PLANNING & ZONING COMMISSION
MEETING
SAMUEL E. DEAN BOARD ROOM
BUTLER GOVERNMENT CENTER
1200 OAK BROOK ROAD
OAK BROOK, ILLINOIS
630-368-5000

Regular Meeting
Wednesday, October 2, 2024
6:30 PM

SUBDIVISION AMENDMENT **3601 & 3505 ADAMS**

DESCRIPTION: Subdivision Amendment L2KM2 Subdivision – 7.64 acres – Final Plat

Boundary/Topographic Survey and Demolition Plan

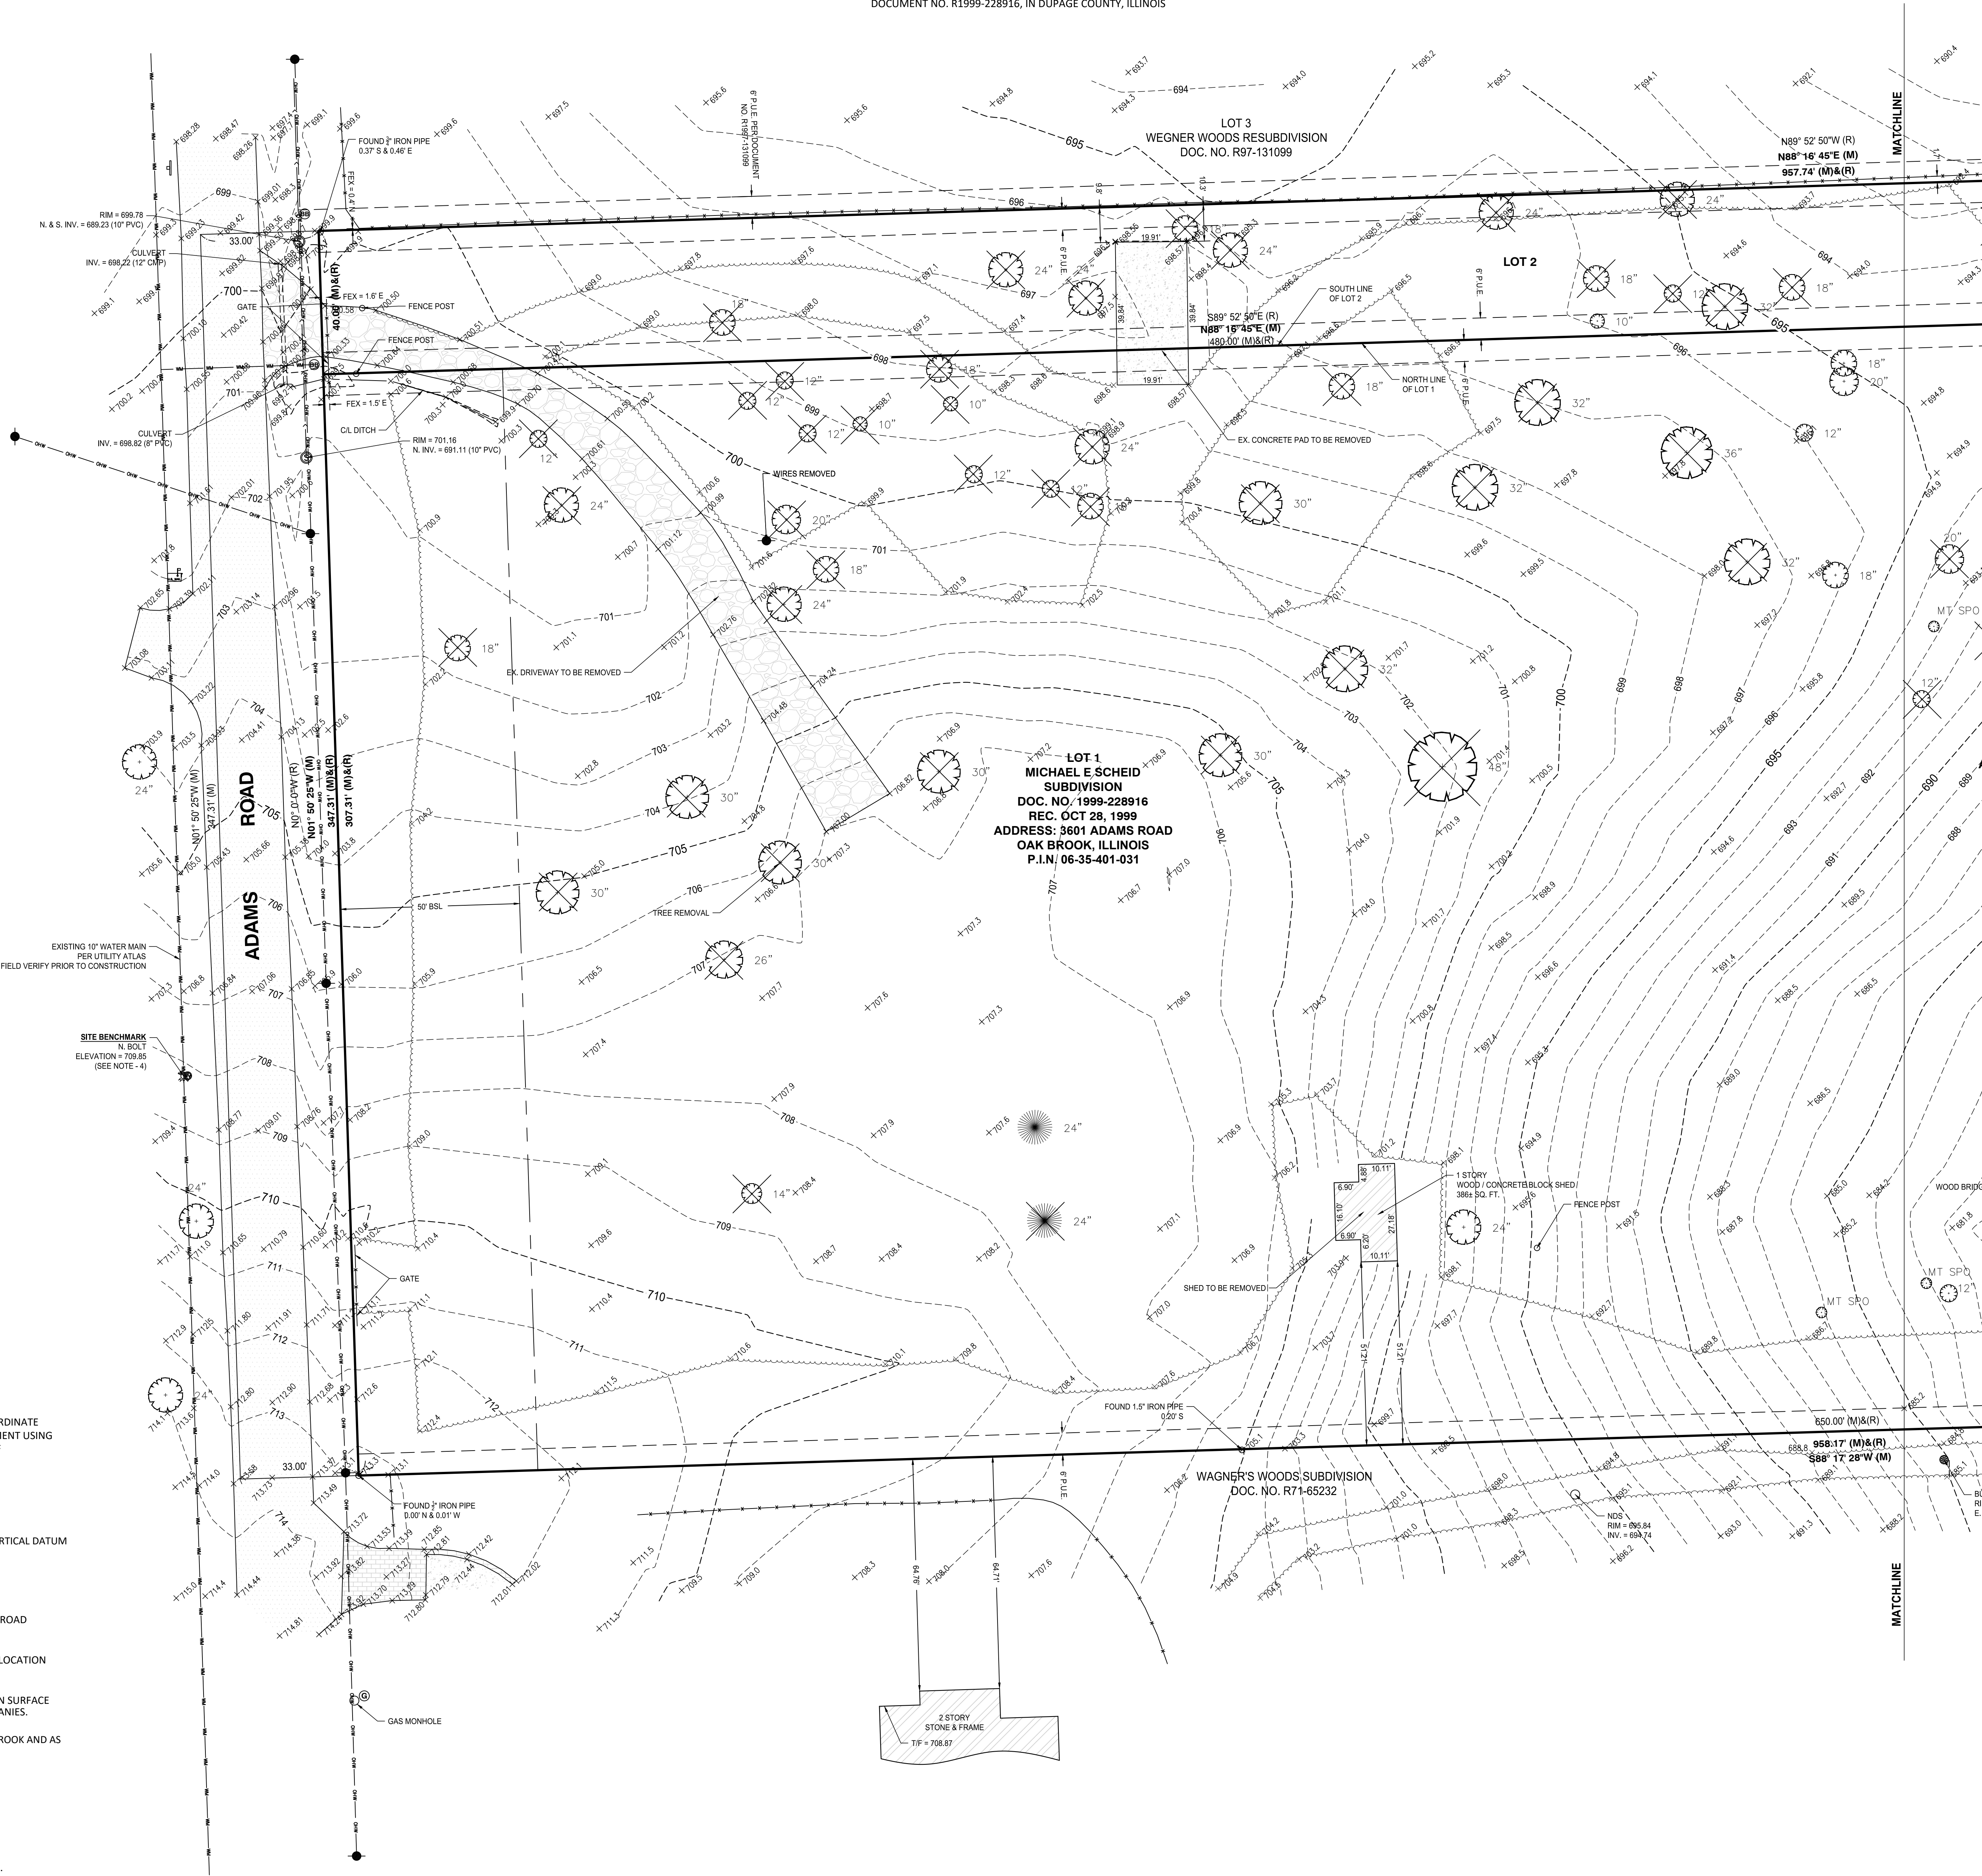
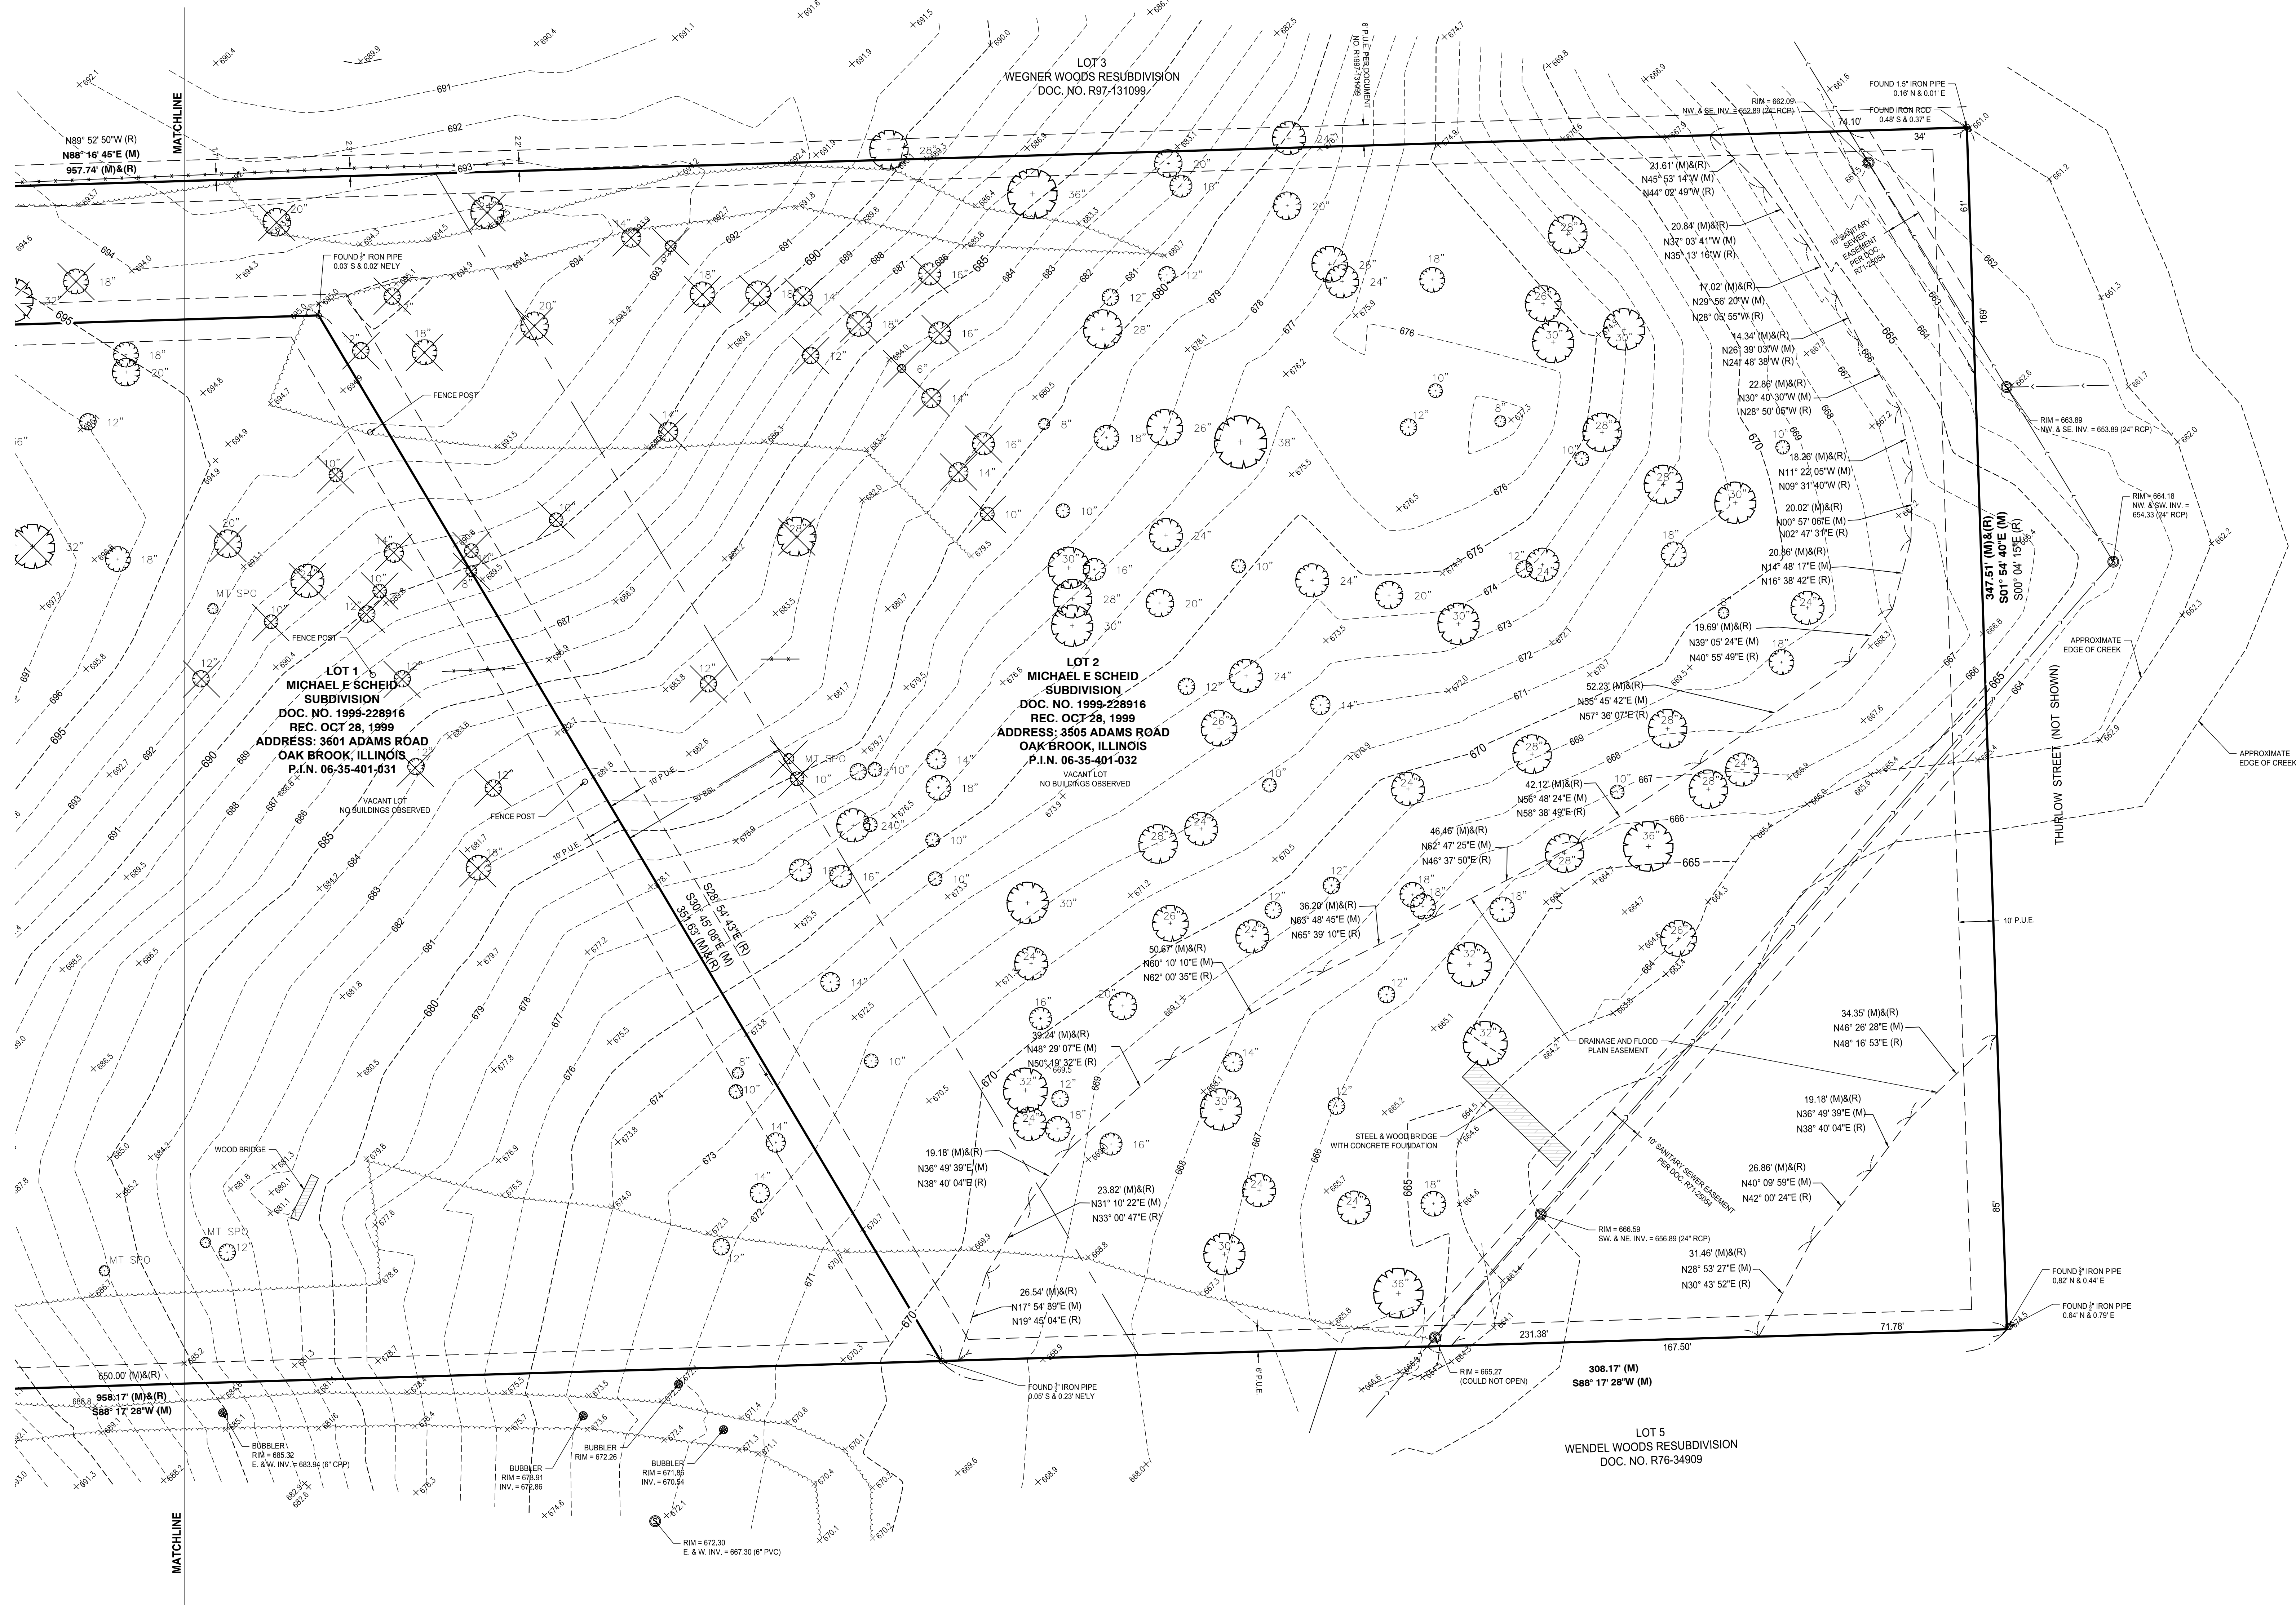
3. (2nd Request) The development site is located within a regulatory floodplain. Provide the applicable FIRM and FIS profile with the approximate location of the development site indicated on each. The BFE for the development site shall be indicated on the preliminary engineering plans, FIRM, and FIS profile.

5. Title 14-4-2.C.2 (and 14-6-2.B.8) – When compared to the topographic survey, the proposed limits of the Drainage and Floodplain Easement do not align with the indicated BFE of 668.4 as shown on the Preliminary Engineering Plans. Revise accordingly.
6. Title 14-6-2.B.1 – Please note that flag lots shall not be permitted unless after review by the Village Engineer, Planning and Zoning Commission, and Board of Trustees, a determination is made that the land in question cannot be reasonably developed in any other way. A response to this comment is not necessary.
